National Highways Planning Response (NHPR 24-01) Formal Recommendation to an Application for Planning Permission

Council's Reference: PA/2023/421

Proposal: Planning permission for the construction and operation of a post-combustion carbon capture plant, including carbon dioxide compressor and metering, cooling equipment, stacks, substations, internal roads, partial ditch realignment, new and modified services, connections, accesses, maintenance and laydown areas.

DevHU0163 Phillips 66 and VPI

Figure 2. Traffic Conditions - M180 Junction 5²

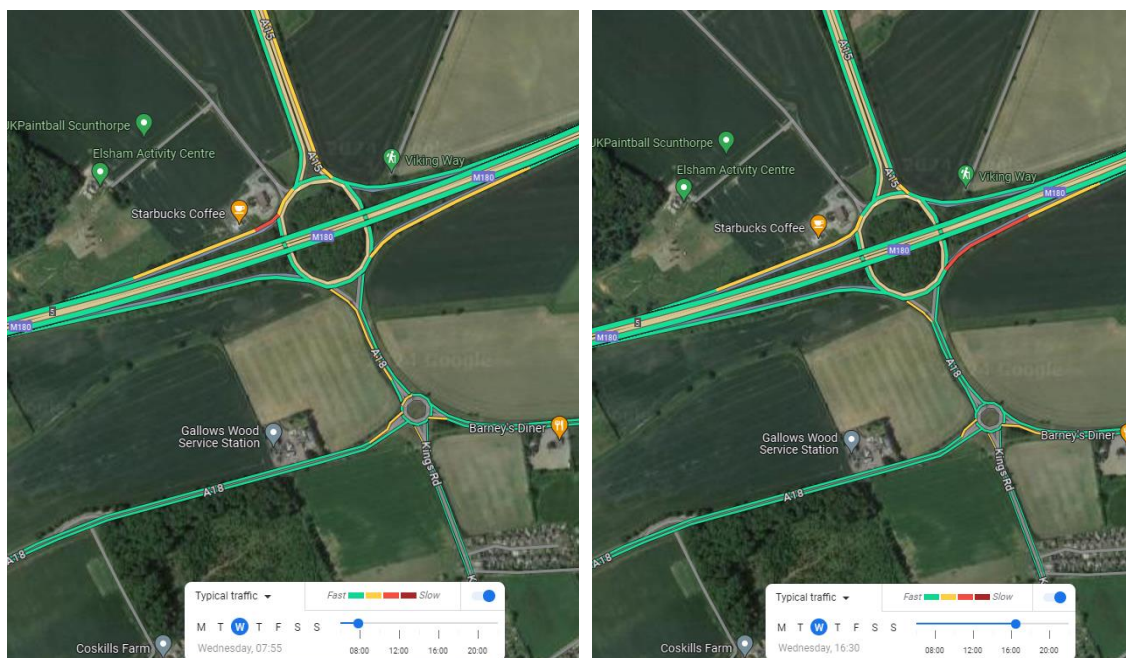
The typical traffic conditions from Google Maps suggests that M180 Junction 5 experiences queuing during the PM peak hour, as shown in **Figure 2**.

- We acknowledged there is concern with queueing at M180 Junction 5 which is forecast to worsen as a result of the construction of the proposed development;

- We noted that even with the BLP mitigation there is concern over the forecast MMQ at the junction; albeit we acknowledged that the development impact is during the construction phase. Hence, the impact at this junction should be addressed within the Construction Traffic Management Plan (CTMP) required as a condition of any consent; and

- The CTMP should consider issues, including but not limited to, actual on-site queueing, forward visibility to the back of the queue (as documented) and the need for mitigation measures to address safety concerns before they arise. This will likely require constant monitoring of impacts.

Figure 5. Traffic Conditions - M180 Junction 4³

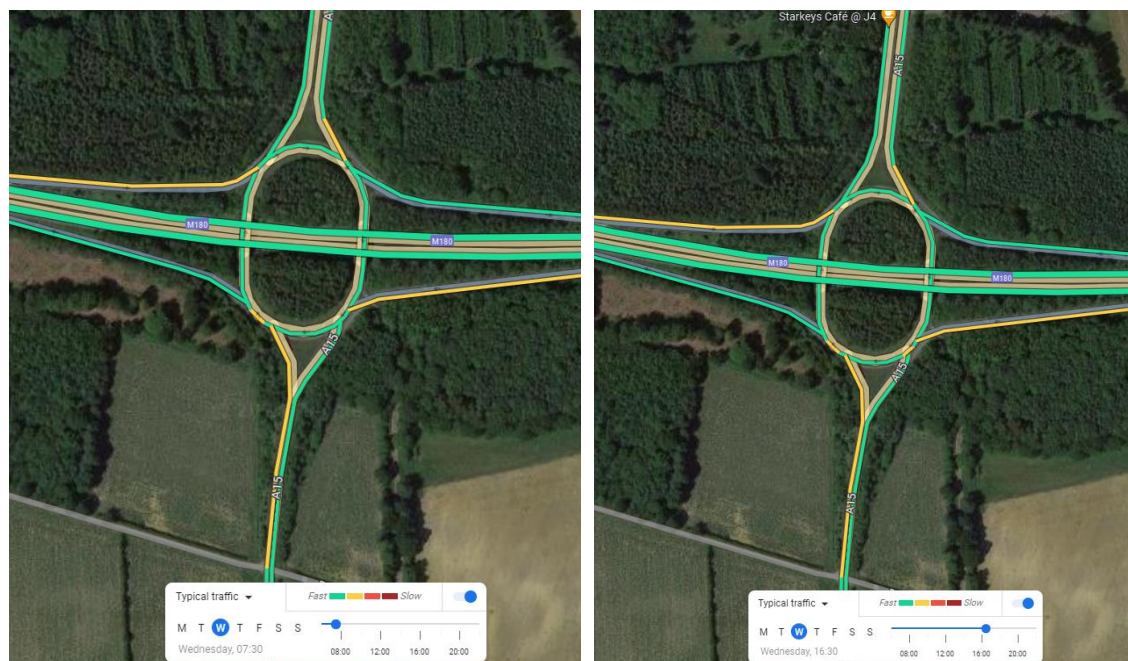
The typical traffic conditions from Google Maps suggest that M180 Junction 4 does not currently experience significant delays during the AM and PM peak hours, as shown in **Figure 5**.

- We acknowledged that there is concern with queueing at M180 Junction 4 which will be made worse by the proposed development; albeit the development impact is during the construction phase.

- Hence, the impact at this junction should be addressed within the Construction Traffic Management Plan (CTMP) required as a condition of any consent; and
- The CTMP should consider issues, including but not limited to, actual on-site queueing, forward visibility to the back of the queue and the need for remedial measures to address safety concerns.
